**COUNTY OF ALBEMARLE**  
**Department of Community Development**  
401 McIntire Road, North Wing  
Charlottesville, Virginia 22902-4596

**RE: SP201200013 Kenridge**  
TAX MAP 60K PARCELS A1, A2, B1, B2, B3, 1-47, 49-61

#### Amendment to Condition #9 of SP 20090006:

### AMENDMENT TO SP 20090006 CONDITION #9

KENRIDGE  
ATTACHMENT "E-1"  
SCALE 1" = 8'

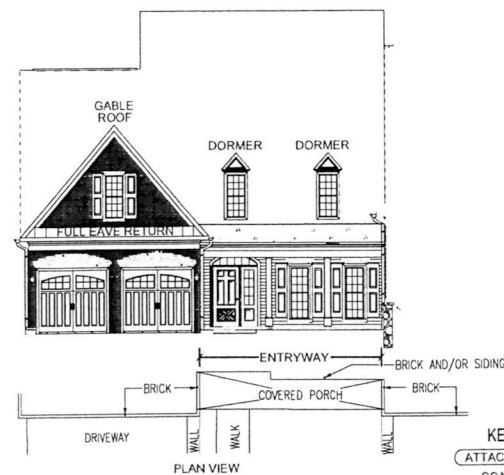
- a. Front facing exteriors shall consist of gable and/or hip roofs with red brick to the roof line. (See Attachments E-1 and E-2)
    - b. Side facing exteriors shall consist of gable and/or hip roofs with red brick to the full eave return and/or roof line (See Attachment E-2). As an alternative to red brick, white composite siding is permissible above said full eave return to the roof line.

- a ) Front facing exteriors shall consist of gable and/or hip roofs with red brick to the roof line (See Attachments E-1 and E-2)
- b.) Side facing exteriors shall consist of gable and/or hip roofs with red brick to the full eave return and/or roof line (See Attachment E-2). As an alternative to red brick, white composite siding is permissible above said full eave return to the roof line.

KENRIDGE  
ATTACHMENT "E-2"  
SCALE 1" = 8'

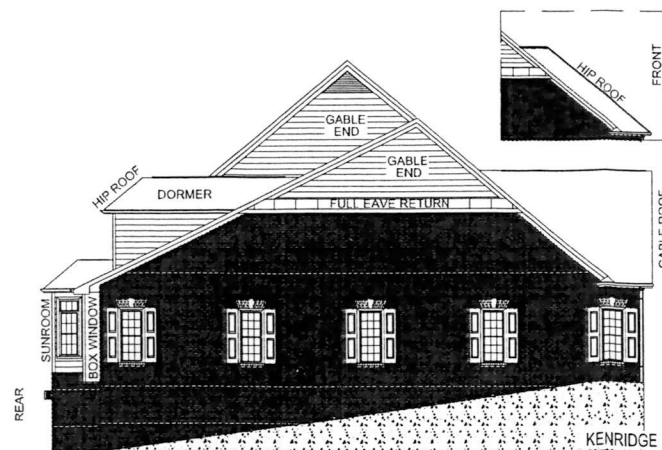
- c. Rear facing exteriors shall be red brick from the ground floor to the roof line except as follows (See Attachment E-3):

- i. Lot 19 shall be red brick from the ground floor to the first floor. White composite siding is permitted from the first floor to the roof line.
    - ii. Lots 30, 31, and 32 shall be red brick from the ground floor to the second floor. White composite siding is permitted from the second floor to the roof line.

- c.) Rear facing exteriors shall be red brick from the ground floor to the roof line except as follows (See Attachment E-3)
- i.) Lot 19 shall be red brick from the ground floor to the first floor. White composite siding is permitted from the first floor to the roof line

- ii ) Lots 30, 31, and 32 shall be red brick from the ground floor to the second floor. White composite siding is permitted from the second floor to the roof line

KENRIDGE  
ATTACHMENT "C"

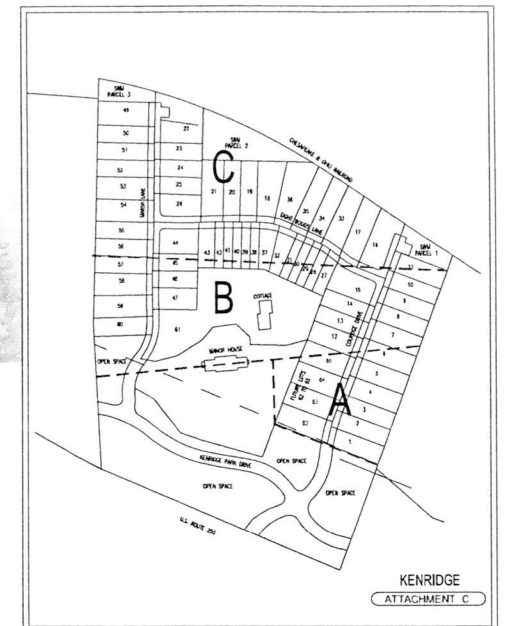
- IV. The exterior of the Manor House and Cottage (See Attachment "C") shall be white painted brick.
  - V. Exterior materials for all buildings within Zone A, (See Attachment "C") shall be reviewed and approved by the Architectural Review Board and by the Director of Planning or their designee before the issuance of a building permit.

- V.) The exterior of the Manor House and Cottage (See Attachment "C") shall be white painted brick
- VI ) Exterior materials for all buildings within Zone A, (See Attachment "C") shall be reviewed and approved by the Architectural Review Board and by the Director of Planning or their designee before the issuance of a building permit.
